KEWEENAW BAY INDIAN COMMUNITY

April 6, 2010

Re: Underground Injection Control (UIC) Permit; Kennecott Eagle Mine, Marquette County, Michigan

1 TREATED WATER INFILTRATION SYSTEM - SCHEMATIC
 NOT TO SCALE

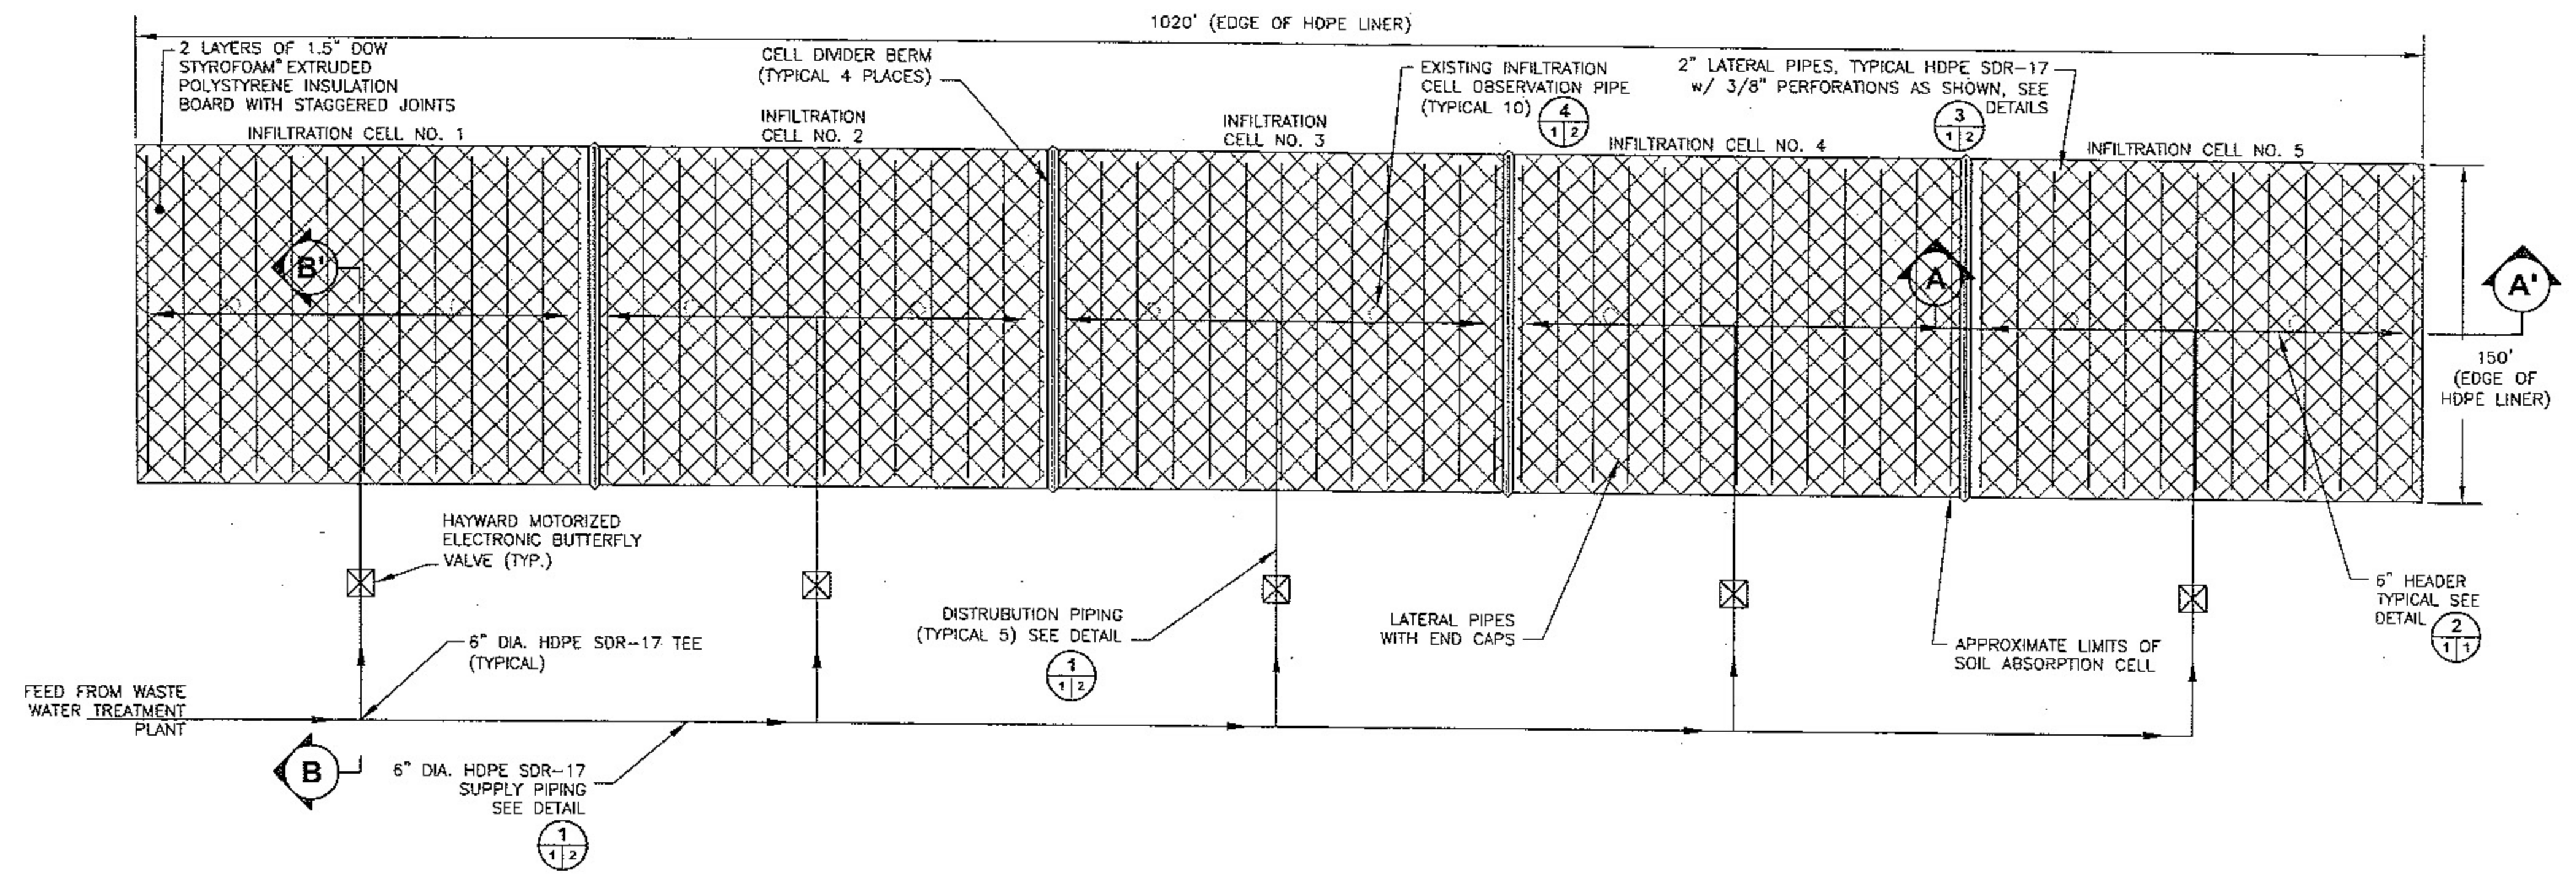
When the construction drawings for the 2006 Design are compared to the 2010 Design Modification it is clear that, **there is no change of the elevation of the piping system** – both design drawings clearly show the waste water distribution piping at the same elevation, i.e., at the existing grade. Moreover, both MDNRE and KEMC representatives have stated publicly, and repeatedly, that the actual elevation of the distribution piping is exactly the same in both the 2006 and 2010 designs. Besides minor changes in pipe size and washed stone thickness, the only substantive change in the 2010 Design Modification from that depicted in the 2006 Design is that the piping system would be covered, for purposes of insulation from freezing conditions, by Styrofoam insulation instead of insulation by a man made mound of soil.

The UIC definition of “subsurface fluid distribution system”, which is “an assemblage of perforated pipes, drain tiles, or other similar mechanisms **intended** to distribute fluids below the surface of the ground” is exactly what is depicted in KEMC’s 2010 Design Modification and the 2006 Design. Based on the UIC definition of “well injection” by use of a “subsurface fluid distribution system”, the pertinent concept or trigger for a UIC permit requirement is the “intent” of the system to “distribute fluids below the subsurface of the ground”. Moreover, the definition does not require that the “system” of perforated pipes, etc., be located underground. It should be noted, as discussed above, the original TWIS system of “perforated pipes” which prompted the EPA Call – In Notification (March 22, 2007) was at existing grade and not underground, and was located at exactly the same elevation (at grade) as specified for the “perforated pipes” in the 2010 Design Modification

The 2010 Design Modification **substitution** of a Styrofoam insulation system for a man made mound of soil insulation system for the piping of the subsurface fluid distribution system, as specified in the 2006 Design, does not change or have any effect on the volume or industrial nature of mine waste water that will be discharged by KEMC's assemblage of perforated pipes which is **intended** to distribute fluids below the surface of the ground and ultimately to an underground source of drinking water.
